PLANNING COMMISSION
TUESDAY, MAY 14, 2019
Sycamore Room - 1st Floor - 6:30 P.M.
201 West Ash Street, Mason MI

<p>City of Mason Planning Commission Staff Report</p>
---	--

TO: Planning Commission
FROM: Elizabeth A. Hude, AICP, Community Development Director
SUBJECT: 801 N. Cedar St. – City Limits
DATE: May 9, 2019

Jim Cicorelli, City Limits, is requesting Final Site Plan Approval to construct a 4,828 square foot addition to expand an indoor recreation use, and to expand parking on property located at 801 N. Cedar Street. The proposal is shown on the following plans and documents:

CITY LIMITS
CIVIL - OVERALL SITE PLAN

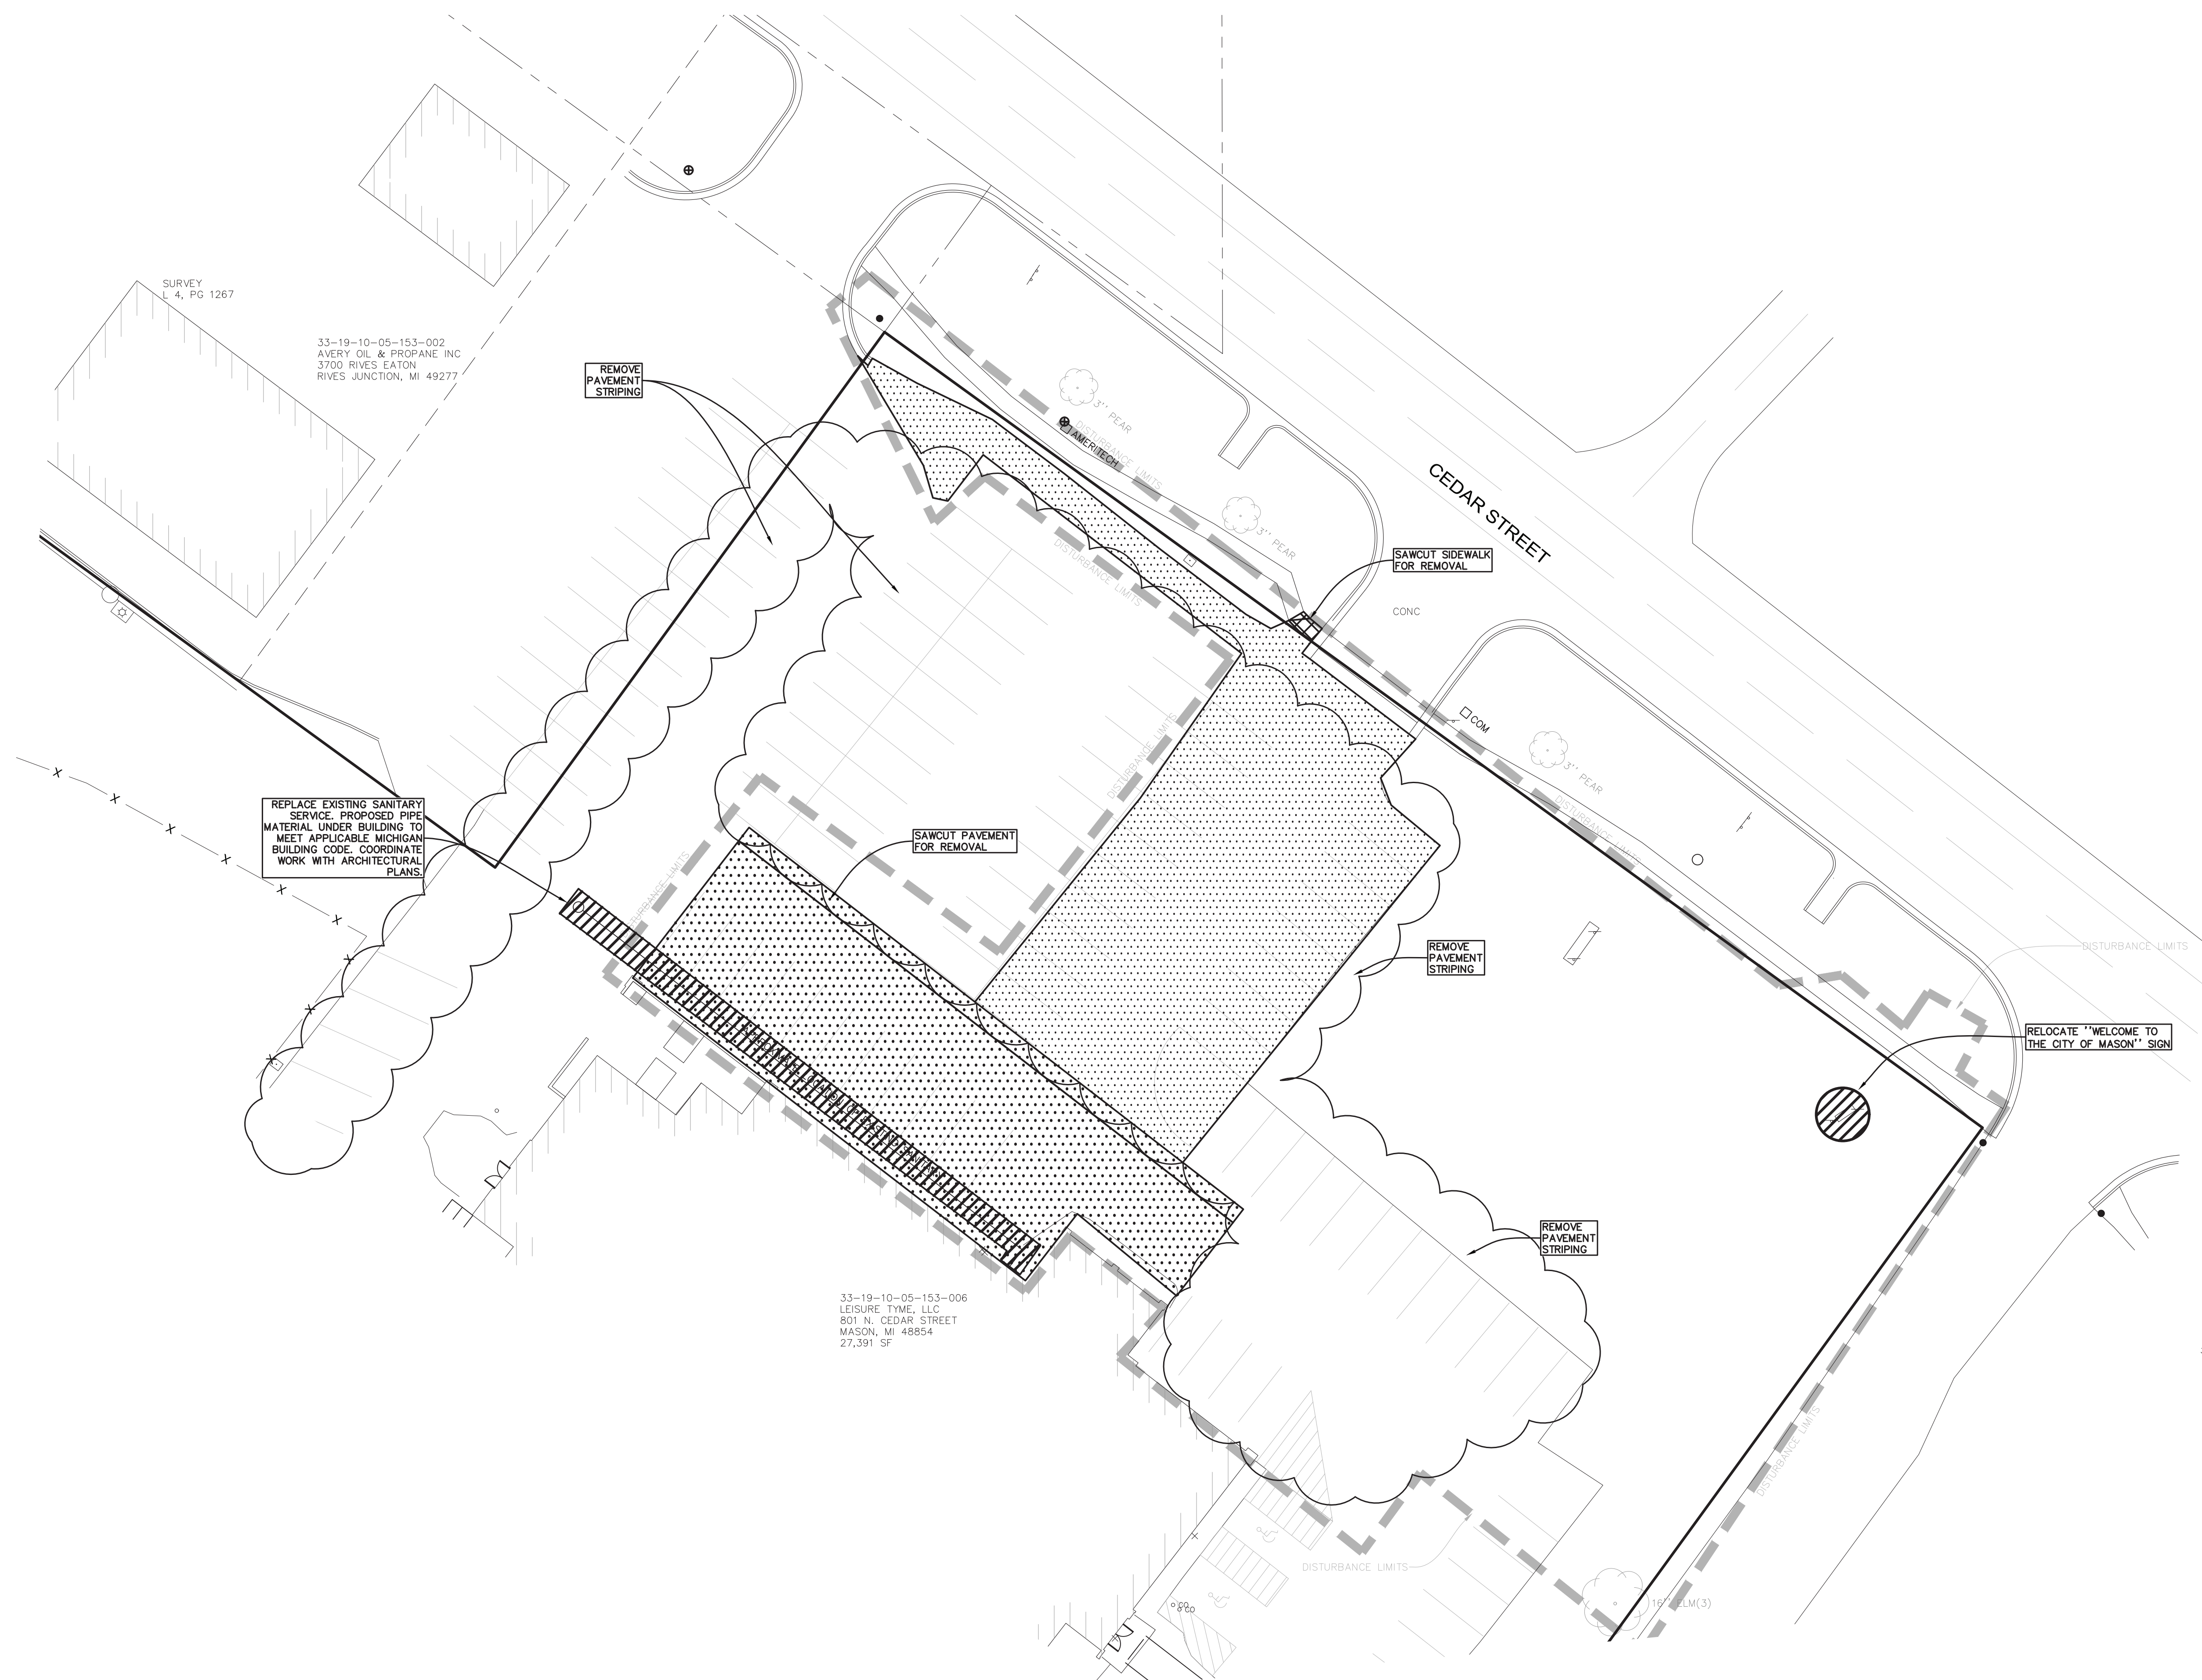
D/W	Sec. 94 – Art. X Off-street Parking and Circulation	
<i>The proposed plan appears to meet the requirements for the number and size of parking spaces. Per Sec. 94-292(j)(3) the applicant is requesting that the Planning Commission allow 18.6% (42 of 233 spaces) measure 180 s.f. (10'x18'). Staff supports the request and adds the observation that there are different peak utilization hours/seasons related to volleyball and bowling.</i>		
<i>Sec. 94-292(j)(1) prohibits parking in a front yard in a C-2 district. The front yard is defined as the area between the front property line and the building line (Figure 100-101) except upon a finding by the planning commission that such parking is a critical component of the operation of the particular use and that adequate provisions are included for the screening and landscaping of such parking area. The existing building is pre-existing and the public entrances are oriented toward the street. The proposed addition will bring the building closer to the street and will displace existing parking near the building. Staff supports a finding that parking is a critical component to the operation of the bowling alley, restaurant and arcade and should be allowed to expand in the front yard subject to the landscaping requirements. SEE LANDSCAPING DISCUSSION.</i>

D/W	Sec. 94-241 Landscape, screening and buffer requirements	
<i>It appears that per Sec. 94-241(e)(6) the Planning Commission has the ability to waive requirements in Sec. 94-241. The applicant has submitted a request for waivers from the landscaping requirements. Therefore, the Planning Commission may choose to waive the requirements as requested so long as the intent to provide landscaping within parking areas, and to enhance aesthetic and ecological qualities, character, privacy, and land value is met. The Planning Commission has the option to accept the proposed plan and waive the requirements for the landscaping pursuant to Section 94-241 (e)(6), or require the plan to be revised with the required vegetation. Further, Sec. 94-241(e)(3) requires the Planning Commission make findings related to the parcel dimensions and/or topography for waivers from buffer requirements as follows:</i>

<i>Sec. 94-241(b)(2)c – Minimum scale of 1" = 20'; the actual scale is 1" = 40'</i>		
<i>Sec. 94-241(b)(2)e – Plan is not sealed by a registered landscape architect</i>		
<i>Sec. 94-241(e)(1) – The plan does not provide the required buffer landscaping. See discussion below.</i>		
<i>Sec. 94-241(i) – The plan does not provide the required amount of off-street landscaping.</i>		
<i>Table 100-4 sets forth the required landscape buffers for the C-2 Zoning District.</i>		
	Zoning	Landscape Buffer Required
North (front)	C-2 (Dandy Randy)	A

The westerly side of the property is adjacent to the MDOT right of way is screened with existing vegetation. No change is proposed to the south rear buffer which abuts undeveloped property. It is staff's opinion that the addition of vegetation along the south and westerly property line in strict accordance with the requirements of Buffer Zone B is excessive.

The existing parking area in the front yard will be improved by adding two trees within two landscape islands measuring approximately 350 sq. ft. per island for a total of 700 sq. ft. The islands will improve the aesthetics of the property and provide better visual cues for traffic circulation.

- A waiver is granted to allow 42 of 233 spaces (18.6%) to measure 180 s.f. (10'x18')
- A waiver of the landscaping requirements is granted and landscaping is approved as shown on the plan
